V2500-A5 SERIES PROPULSION SYSTEM SERVICE BULLETIN

This document transmits Revision 2 to Service Bulletin EV2500-73-0185 and Revision 2 to the Supplement

ENGINE – FUEL AND CONTROL – EEC150-40 PRESSURE BURNER SENSOR PORT SCREEN DELETION

FAMILY TREE - ELECTRONIC ENGINE CONTROL (EEC) REF. CATALOG SEQUENCE NO. 73-22-34,
FIG. 01 ITEM 280

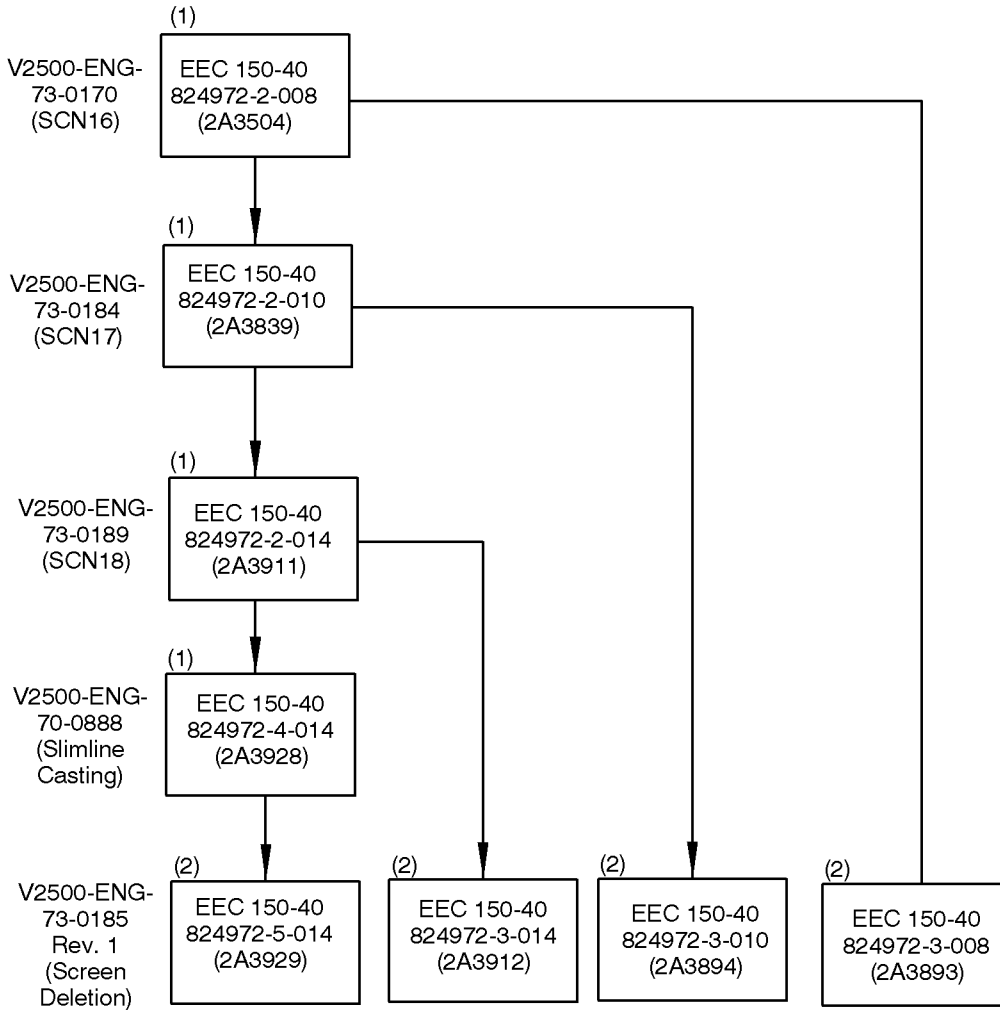
PART NUMBER CHANGE

(1) WITH Pb SCREEN
(2) Pb SCREEN DELETED
